Master Plan Amendment #2020-00003
CDD Concept Plan #2020-00003
Zoning Text Amendment #2020-00006
2412, 2514 & 2610 Richmond Highway; 2500 Oakville Street; 400 Fannon Street; 300, 403, 405 & 420 Swann Avenue; 400 Calvert Avenue

Approval of amendments to the Potomac West Small Area Plan chapter of the Master Plan through the Oakville Triangle & Route 1 Corridor Vision Plan and Urban Design Standards & Guidelines overlay, amendments to CDD#24 Concept Plan, and initiation of and text amendment to the Zoning Ordinance for a mixed-use development of the Oakville Triangle with Conditions.

*MPA2020-00003, CDD2020-00003, ZTA2020-00006
Oakville Triangle Vision Plan & CDD Concept Design Plan Amendments*

CDD Open Space Exhibit

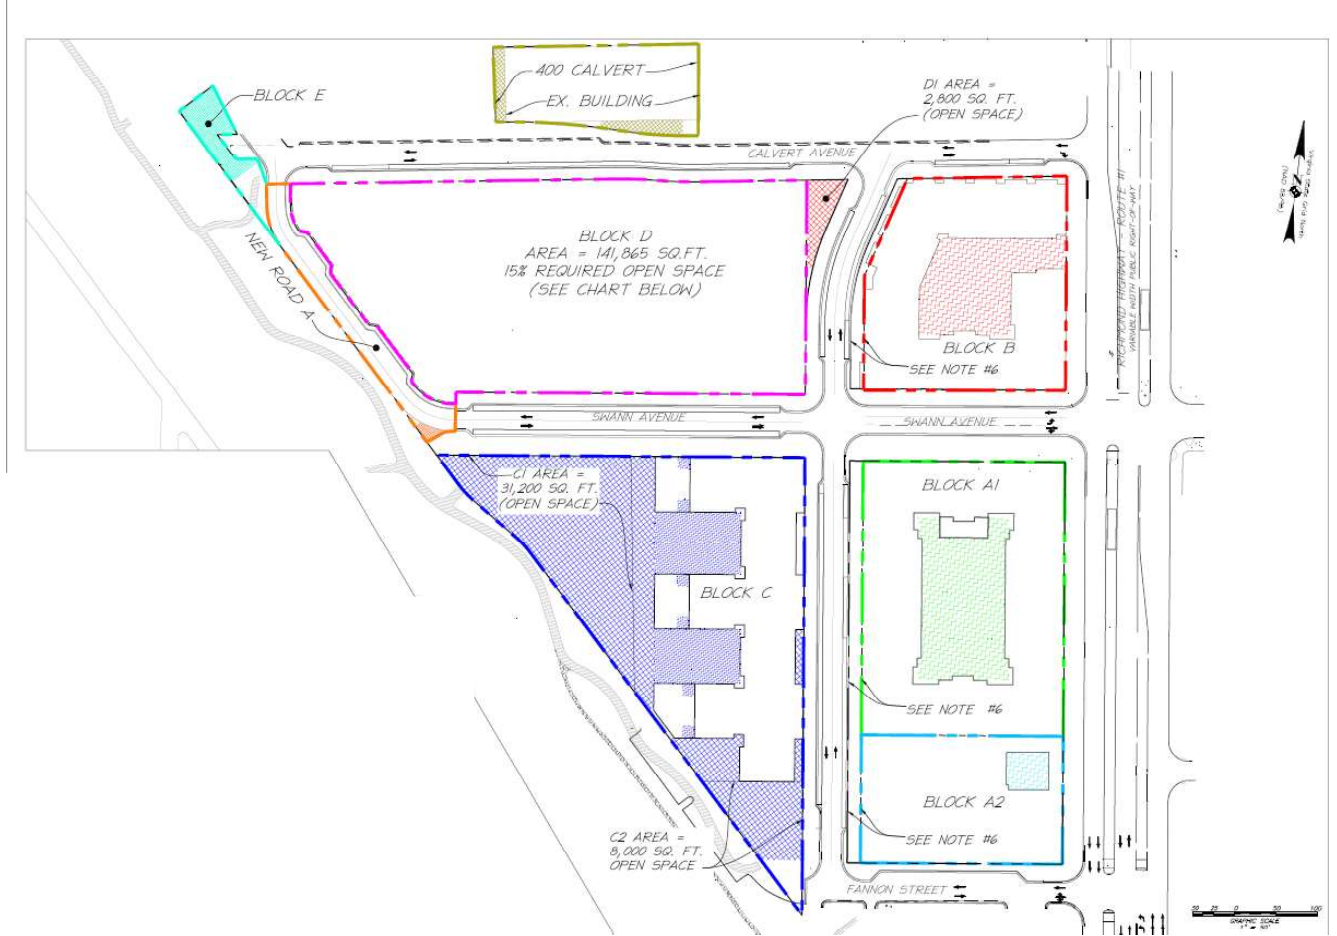
32. A total of 40% (approximately 105,966 sf) of the mixed-use development land area (approximately 264,915sf) as shown on Sheet C3.0 title Open Space Exhibit, of the CDD Concept Plan shall be provided as useable open space or rooftop amenity space. A minimum of 20% (52,983) of the mixed-use development land area shall be as ground-level open space and shall be generally consistent with the CDD Concept Plan submission. A minimum 45,500 sf within the CDP area shall be ground-level open space useable and accessible to the public, as generally depicted on the CDD Concept Plan as areas C1, C2, D1 and Outlot E. The townhome development (Block D) shall provide a minimum of 15% ground-level open space and a minimum 10% roof-top open space. Public right-of-ways and access easements between the property line and the western face of buildings on Block A and B shall not be counted as open space and should not be included in the total area calculations.

35. Ground level open space in Blocks C1 and E as depicted on Sheet C03.0 in the CDD Concept Plan shall be fully open to the public following the hours and guidelines established by the Department of Recreation, Parks and Cultural Activities. Signage for all ground level open spaces with public access easements shall be posted at each site displaying the hours, guidelines and property contact information and shall be designed through the DSUP process to reflect the public nature of the spaces. Guidelines for use of this spaces by the City and/or public shall be developed and agreed upon prior to issuance of first certificate of Occupancy for Block A1 or B. (P&Z)(RP&CA)

36. The total acreage of publicly accessible ground level open space in Blocks C1, C2, D1, and E as depicted on Sheet C3.0 of the CDD Concept Plan is approximately 1.044 acres (45,500 square feet). The applicant shall dedicate perpetual public access easements for each of these areas prior to the issuance of the certificate of occupancy for adjoining development block. (P&Z)(RP&CA)

Exhibit 1. Preliminary Phasing Plan (from C02.1 dated 9/15/2020 and revised 11/03/2020)

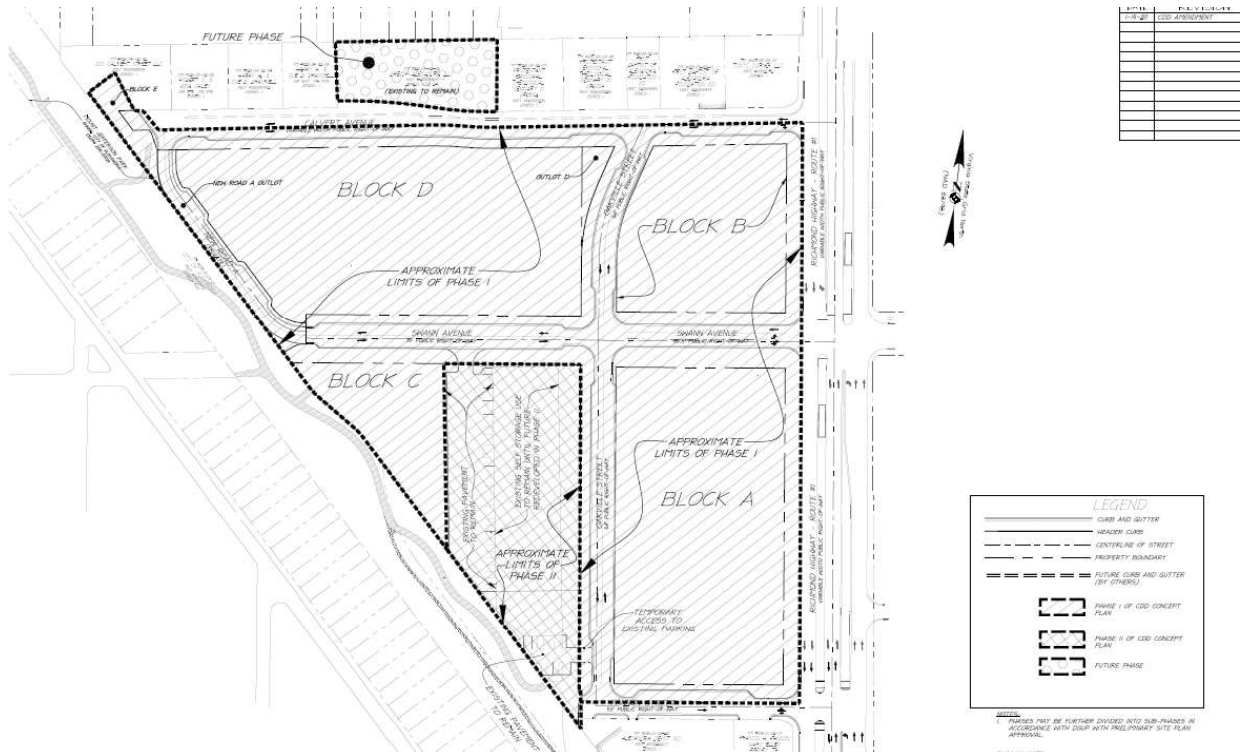
- a. The subject site of the CDP application, hereafter referred to as the “CDP area” is subject to the conditions herein.
 - b. The applicant’s CDD Concept Plan submission defined construction within two broad timeframes, Phases 1 and 2 (referred to as “Phase 1” and “Phase 2” herein). The extents of the respective development and any associated conditions phases shall be as shown in the CDD Concept Plan submission sheet C02.1 ‘Conceptual Design Plan’ “Phasing Plan” (exhibit 1). (P&Z)

Figure 30: Open Spaces adjacent to Mount Jefferson Park

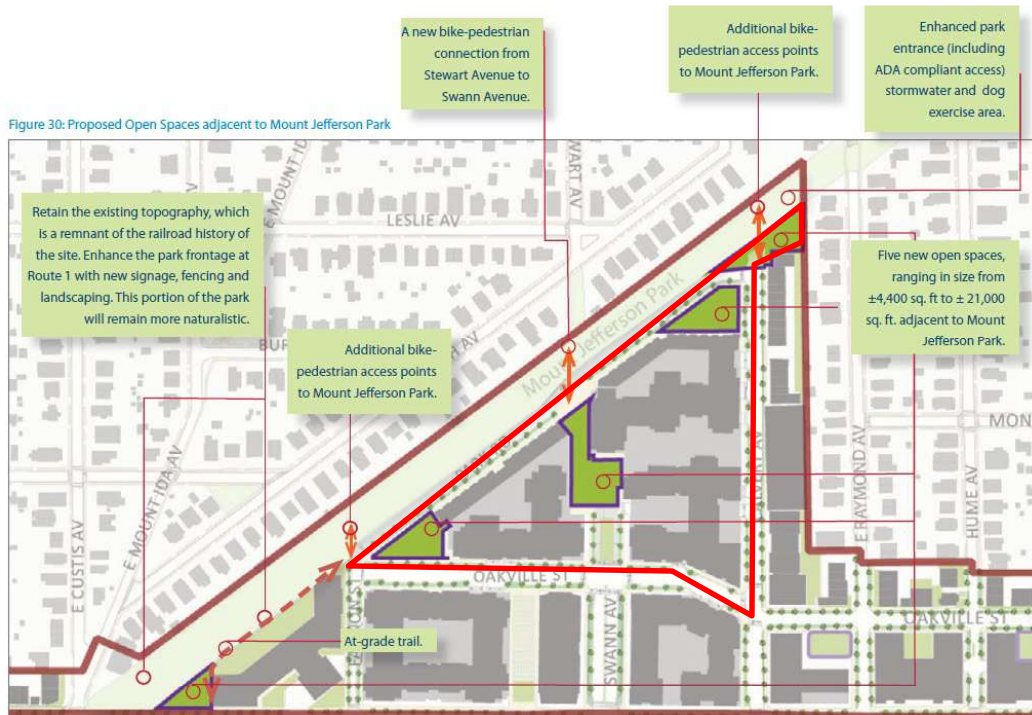
- Amend Standard 4.18, as follows: The ~~five~~ new open spaces adjacent to Mount Jefferson Park shall be constructed as generally depicted in Figure 30, as part of the redevelopment adjacent to the Mount Jefferson Park. The at grade trail (lower trail) extension on the northern portion shall be constructed by the adjoining property owner.

Figure 30: Open Spaces adjacent to Mount Jefferson Park

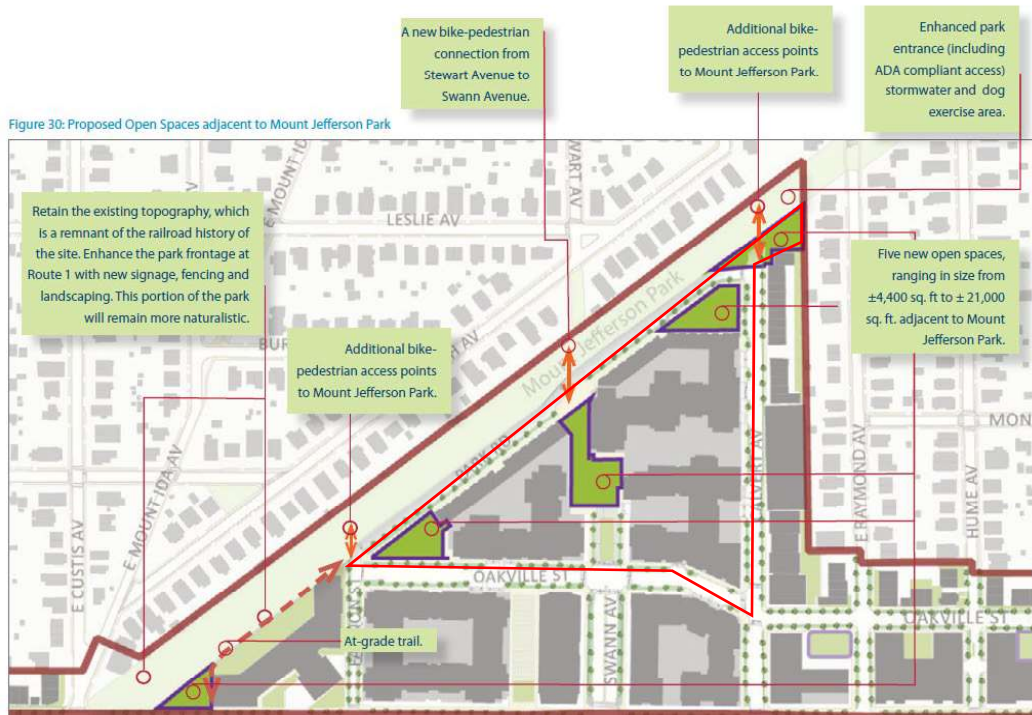
- Amend Standard 4.18, as follows: ~~The five new open spaces adjacent to Mount Jefferson Park shall be constructed as generally depicted in Figure 30, as part of the redevelopment adjacent to the Mount Jefferson Park. The at grade trail (lower trail) extension on the northern portion shall be constructed by the adjoining property owner.~~

- Amend Standard 4.18, as follows: The ~~five~~ new open spaces adjacent to Mount Jefferson Park shall be constructed as generally depicted in Figure 30, as part of the redevelopment adjacent to the Mount Jefferson Park. The at grade trail (lower trail) extension on the northern portion shall be constructed by the adjoining property owner.
- Amend Standard 4.19, as follows: The central open space within Oakville Triangle shall ~~be hardscape with~~ have appropriate plantings, shade options, and lighting and shall contain high-quality materials and finishes, as well as the inclusion of public art or other focal features. The open space/~~plaza~~ shall be accessible to the public through the provision of a public access easement.

Figure 41: Ground Floor Uses: Primary, Secondary Retail, and Maker Spaces

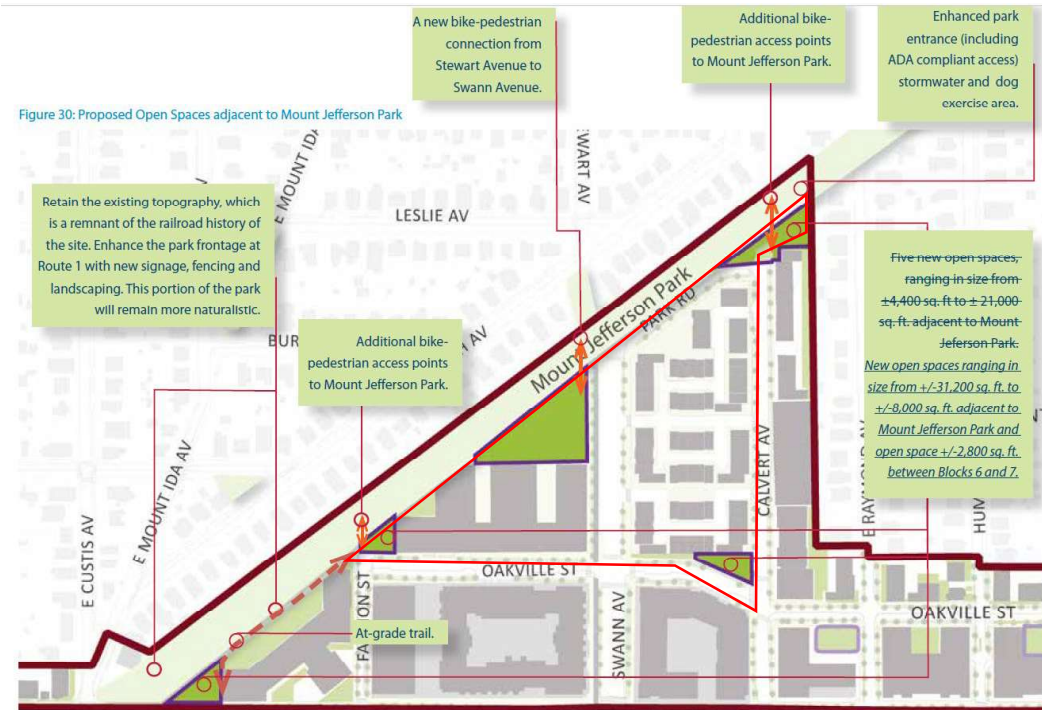
- Amend the title of Figure 41, as follows: Figure 41: Ground Floor Uses: ~~Primary, Secondary~~ Retail, and Maker Spaces
